PG&E Interpreted Plume Outlines

**FIGURE 5-5
CHROMIUM RESULTS FOR SECOND
QUARTER 2015 GROUNDWATER
MONITORING AND DOMESTIC
WELL SAMPLING AND COMPLIANCE
MAXIMUM PLUME OUTLINE
IN UPPER AQUIFER**
SECOND QUARTER 2015 GROUNDWATER MONITORING
REPORT AND DOMESTIC WELL RESULTS
SITE-WIDE GROUNDWATER MONITORING PROGRAM
PACIFIC GAS AND ELECTRIC COMPANY
HINKLEY COMPRESSOR STATION
CH2MHILL

Inset 1

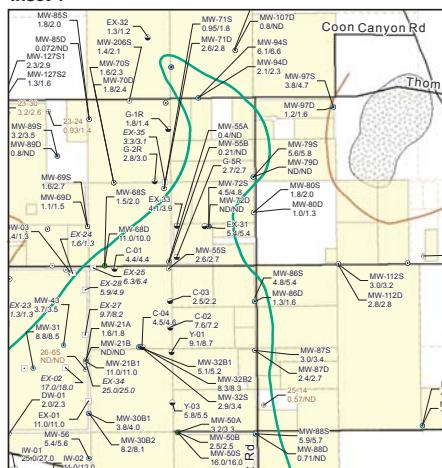
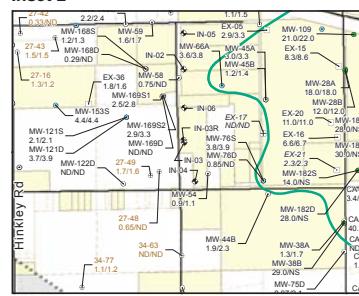
PG&E does not agree with the contouring requirements set forth by the Water Board but has completed this map in accordance with the requested standards. The insets below provide PG&E's interpretation of several areas where they believe the requirements of the Water Board create an inaccurate representation of the chromium plume. These interpretations were created using all available hydrogeologic and geochemical information, applications of industry standard, and professional judgment. These displays present the same information and use the same scale as the larger map area.

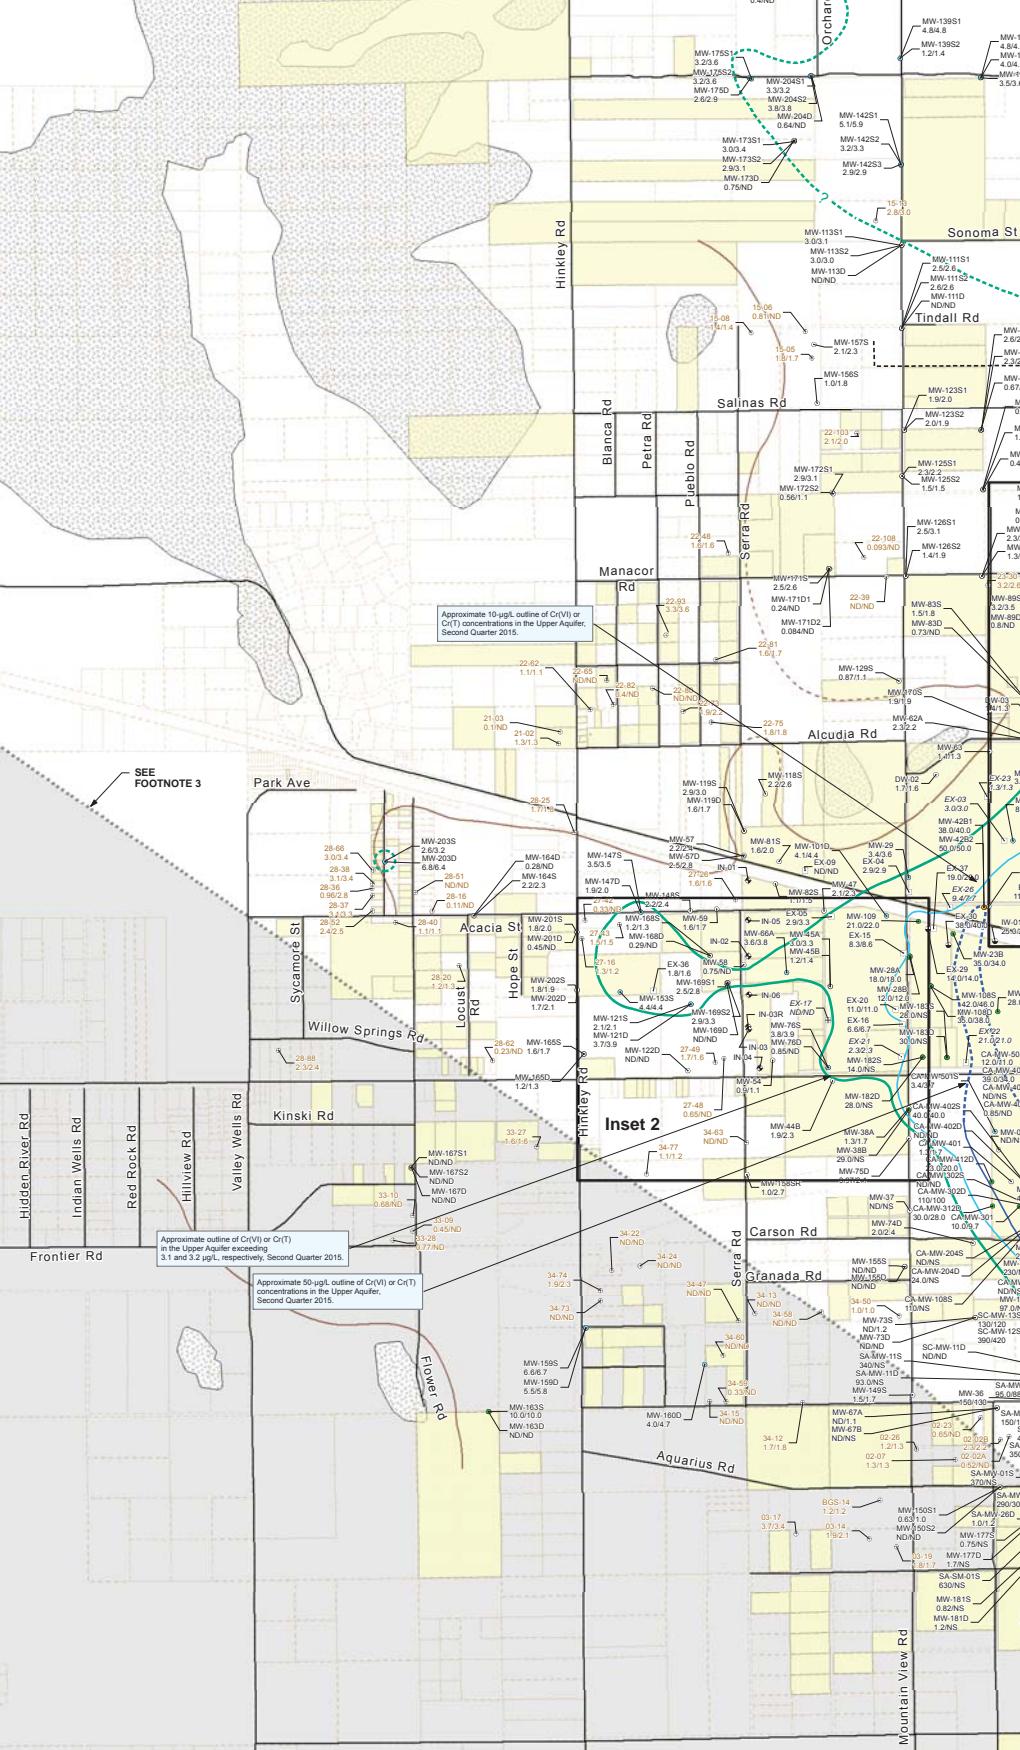
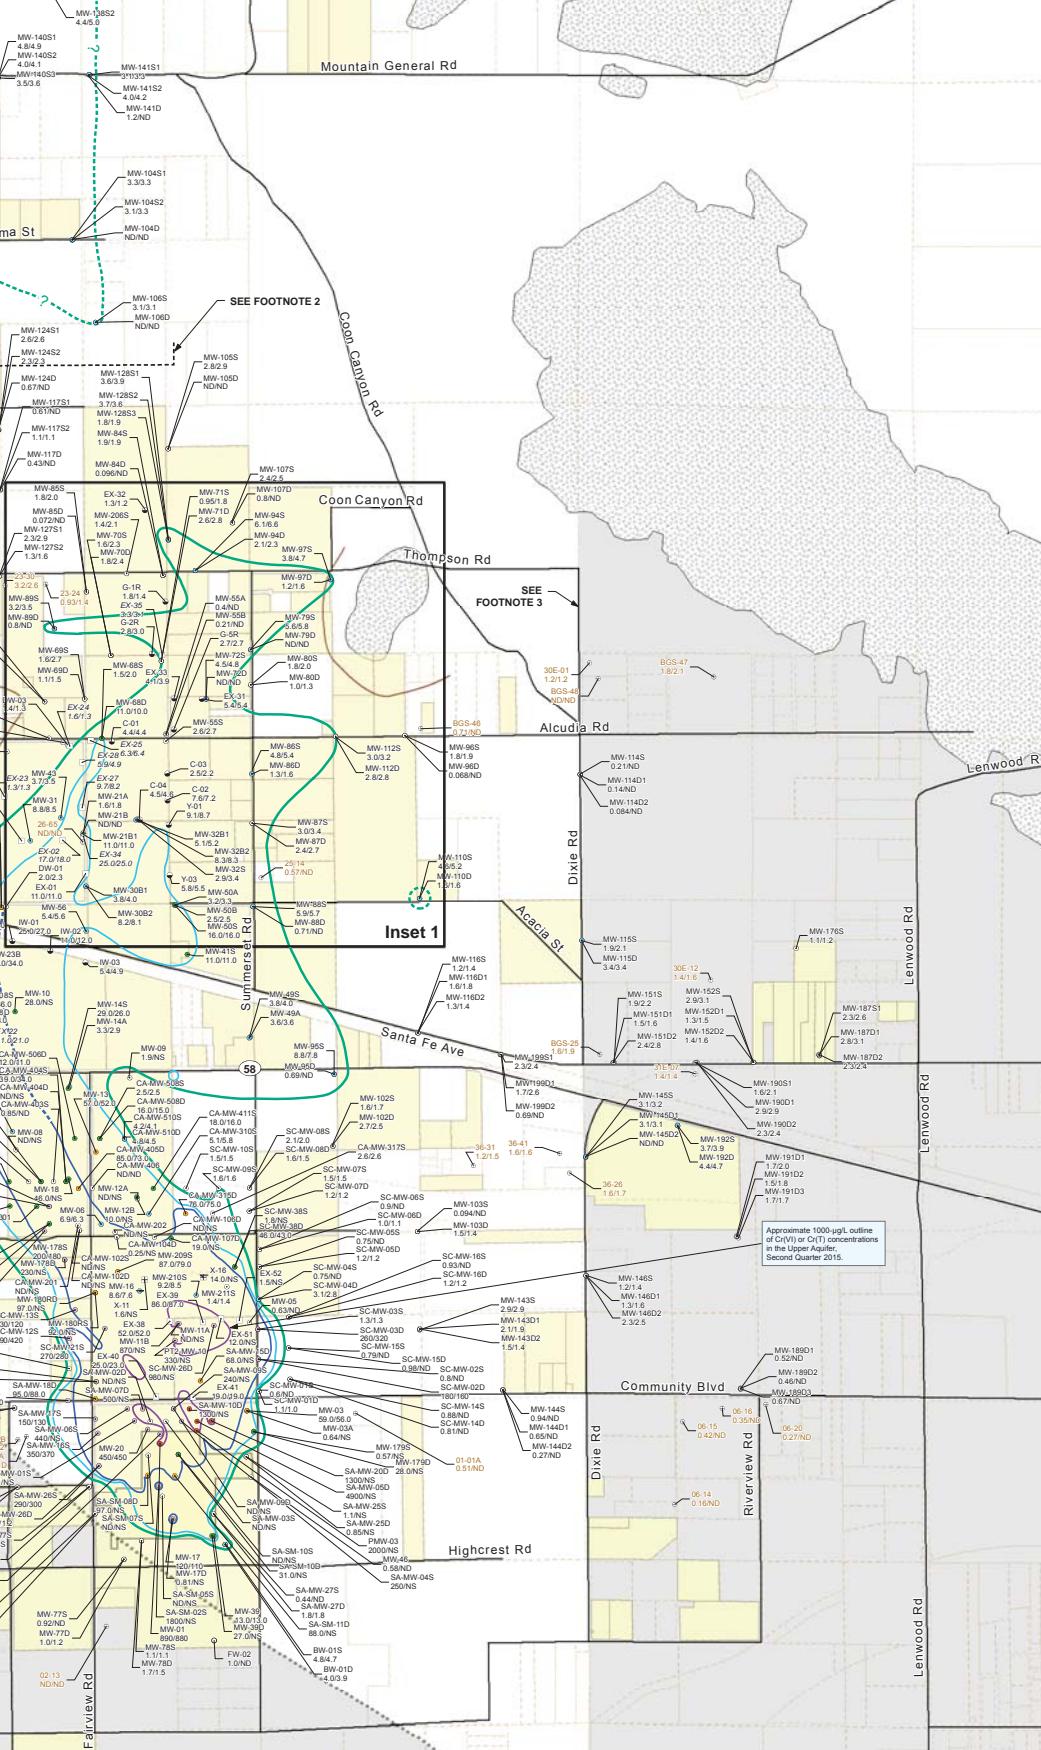
General PG&E Comment to Figure 5-5

- An evaluation of available hydrogeologic and groundwater quality data for the Western Area was included in the January 14, 2013, document titled *Conceptual Site Model for Groundwater Flow and the Occurrence of Chromium in Groundwater of the Western Area Report* (CH2MHILL and Stantec, 2013). The findings of the January 14 report indicate that groundwater in the Western Area contains naturally occurring chromium.

- PG&E does not believe chromium concentrations north of the contiguous plume can be adequately evaluated with the data currently available at this time. Natural chromium concentrations in the northern Hinkey Valley will be evaluated in the upcoming background study to be conducted by the United States Geological Survey.

- Some monitoring wells currently used for contouring produce very little water or purge dry during sampling. Chromium concentrations from these locations, such as MW-15A1 and MW-193S3, may not be representative of the dominant groundwater flow or PG&E's impact to local groundwater.
